Serial No. 10/721,179
Amtd. Dated November 16, 2004
Reply to Office Action of August 18, 2004

Docket No. K-0586

REMARKS/ARGUMENTS

FIG. 2

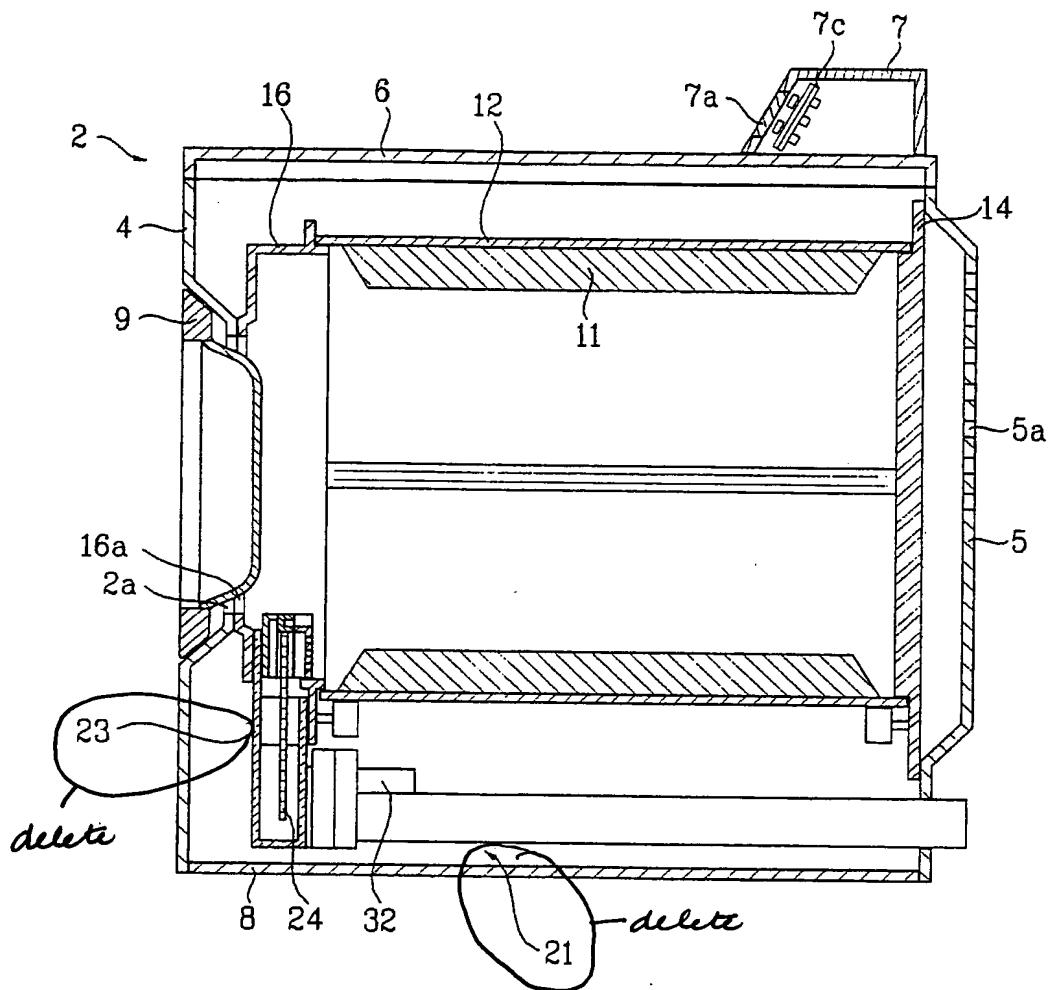
The attached drawings include changes to Figures 2-3. These sheets, which include Figures 2-3, replace the original sheets including Figures 2-3. In Figure 2, reference numbers 21 and 23 have been deleted. In Figure 3, reference number 21 has been deleted.
